Project	IEEE 802.16 Broadband Wireless Access Working Group < http://ieee802.org/16 >	
Title	PKM EAP further developed on section 7	
Date Submitted	2004-08-29	
Source(s)	Dongkie Lee, DongIl Moon, DongRyul Lee, JongKuk Ahn, KangIl Koh, Sihun Ryu, Sungho Ha SK Telecom 15F, Seoul Finance Center, 84, Taepyungpro 1 ga, Chung-gu, Seoul, 100-768, Korea	Voice: +82-2-6323-3147 Fax: +82-2-6323-4493 [mailto: {galahad,dimoon,drlee,jgahn,ss23}@sktelecom.com]
Re:	Recirculation Ballot #14c Announcement	
Abstract	Although PKM EAP was accepted and baseline procedure is defined, further details like state machine and call flow are not described in REVe/D4. In this contribution, PKM EAP text was developed in through section 7.	
Purpose	Discuss and Adopt as the baseline text	
Notice	This document has been prepared to assist IEEE 802.16. It is offered as a basis for discussion and is not binding on the contributing individual(s) or organization(s). The material in this document is subject to change in form and content after further study. The contributor(s) reserve(s) the right to add, amend or withdraw material contained herein.

PKM EAP further developed on Section 7

Although PKM EAP was accepted an

Figure 131 Authorization state machine flow diagram

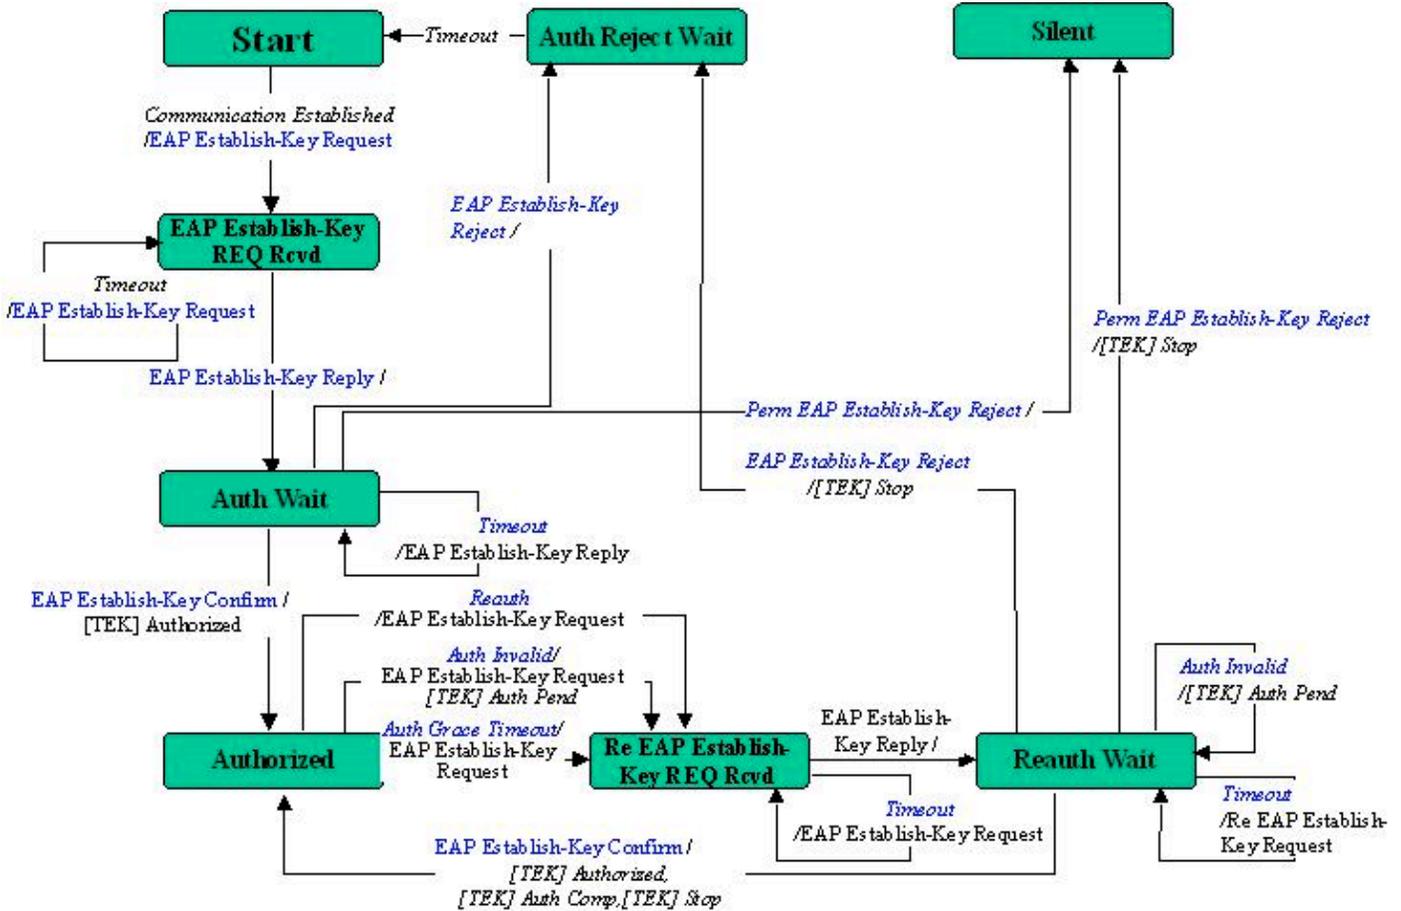
[Add the 7.2.X at the appropriate section separate with the PKM RSA Authorization state machine:]

7.2.X Authorization state machine [for PKM EAP](#)

The Authorization state machine consists of [eight](#) states and [nine](#) distinct events (including receipt of messages) that can trigger state transitions. The Authorization finite state machine (FSM) is presented below in a graphical format, as a state flow model (Figure 131), and in a tabular format, as a state transition matrix (Table 131).

Figure 133 AK management in BS and SS

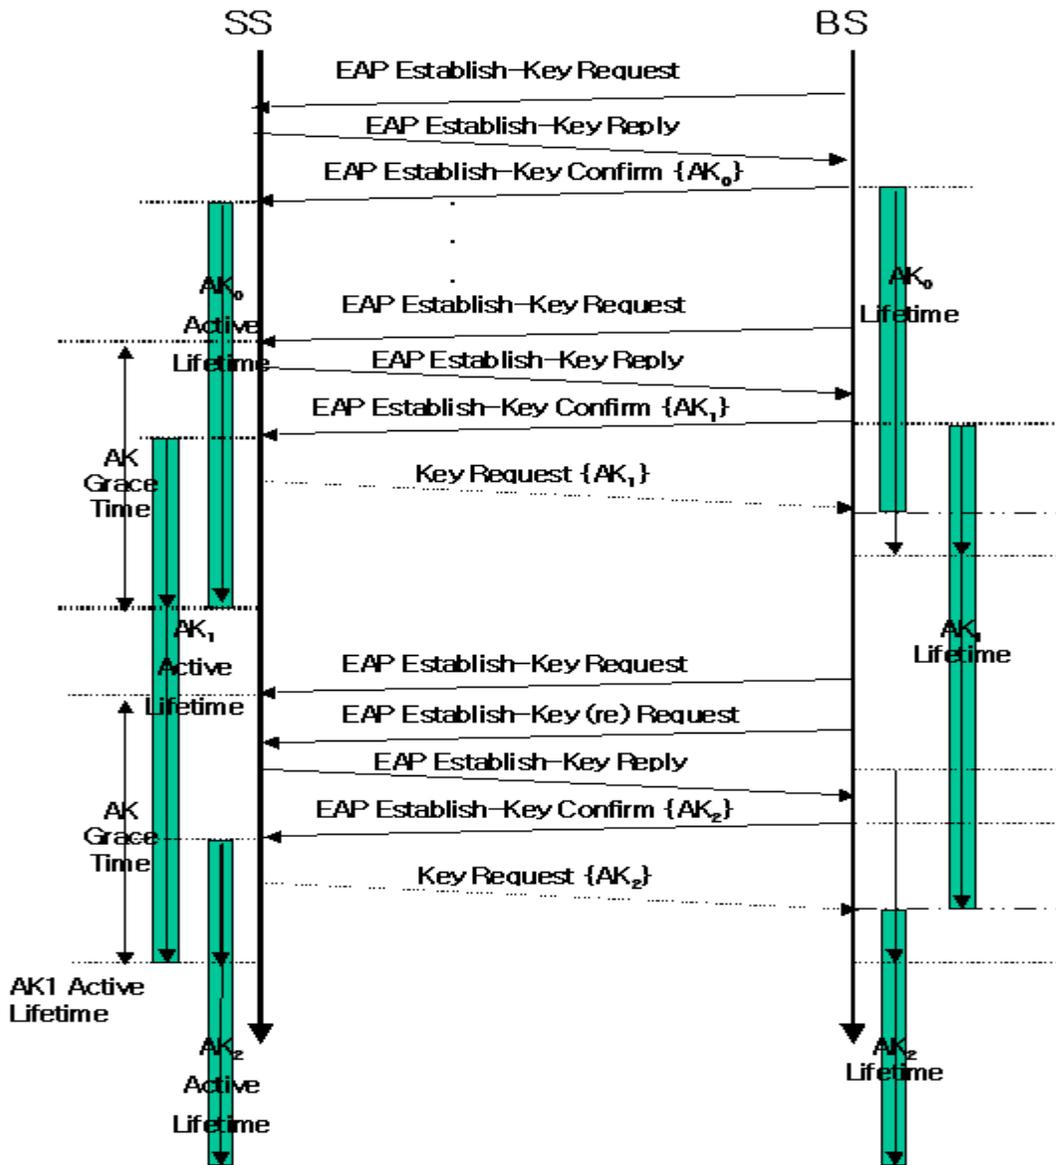
31 [For PKM RSA case, the BS shall always be prepared to send an AK to an SS upon request. For PKM EAP case, the BS shall](#)

34 An AK transition period begins when the BS receives an Auth Request [or EAP Establish-Key Reply following EAP Establish-Key](#)

35 [Request](#) message from an SS and the BS has a single active AK for that SS. In response to this Auth Request [or EAP Establish-Key](#)

36 [Reply](#), the BS activates a second AK [see point (a) and (d) in Figure 133], which shall have a key sequence number one greater

37 (modulo 16) than that of the existing AK and [for PKM EAP case it](#) shall be sent back to the requesting SS in an Auth Reply
